UNITED STATES PATENT AND TRADEMARK OFFICE

APPLICATION NO.	FILING DATE	FIRST NAMED INVENTOR	ATTORNEY DOCKET NO.	CONFIRMATION NO.
10/687,600	10/20/2003	Makoto Morishima	520.43227X00	2551

Office Action Summary	Application No. 10/687,600	Applicant(s) MORISHIMA ET AL.	
	Examiner Raymond Alejandro	Art Unit 1745

DETAILED ACTION

Fig. 6

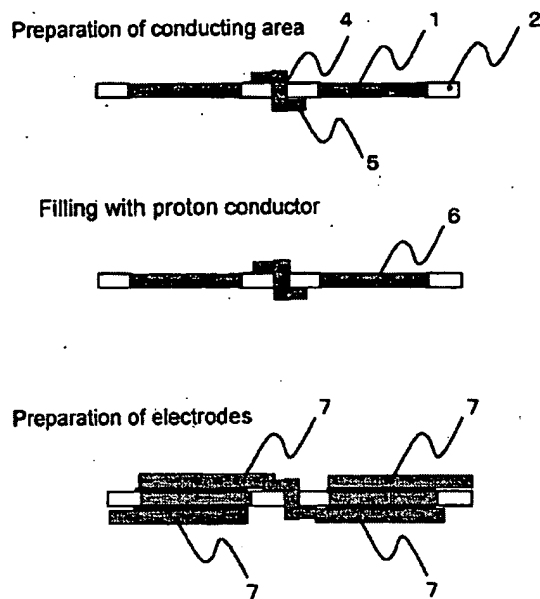
Figure 6 below of Kidai et al depicts a polymer electrolyte membrane comprising a plurality of electrodes 7 consisting of respective electrode substrates and electrocatalyst layers

(P.0058). It is disclosed that connections occur between the anodes and the cathodes located in the opposite sides of the polymer electrolyte membrane, wherein it is preferably to have a structure which interposes electron conductor the polymer electrolyte membrane (P0011). Reference numeral 5 represents the electron conductor through membrane (*the wiring member which electrically connects adjoining electrodes*) ; reference numerals 1 and 2 represent respective porous area and non-porous area of the polymer electrolyte membrane (P0025-0031).

(Emphasis supplied→) EXAMPLE 1 exemplifies the preparation of a multipore film having a porous area 1 and non-porous area 2; wherein the porous area 1 is filled with the Nafion proton conductor (EXAMPLE 1/ P0100-0103). *The electrolyte membrane having a slot may be represented by either the membrane permeating area 4 including the electron conductor through membrane 5 or the multipore film having a porous area (slots).* The anode, cathode and electrolyte are separated by a separator (P0005). *In the instant case, the separators serve as the plurality of wiring plates covering respective cathodes and anodes.* Electrodes 7 are connected through respective electron conductor through membrane 5 (See FIGURE 6).

Examiner's note: *It is noted that the plurality of both negative electrodes and positive electrodes satisfy the claimed requirement of having opposed anode and cathode electrodes in pairs with the solid polymer electrolyte interposed therebetween. It is further noted that the negative electrode performs the inherent function of oxidizing the fuel gas, and the positive electrode performs the inherent function of reducing the oxidant.*

*The electrolyte membrane having a slot may be represented by either the membrane permeating area 4 including the electron conductor through membrane 5 or the multipore film having a porous area (slots) (See **EXAMPLE 1** or **FIGURE 6**). Certainly, the slots are formed around the cathodes and the anodes (i.e. proximate to or in the vicinity of the cathodes and anodes); and they are positioned between adjacent anodes and cathodes. In a fuel cell stack configuration, any slot of the slots can be said to be provided between every two adjoining anodes and between every two adjoining cathodes.*
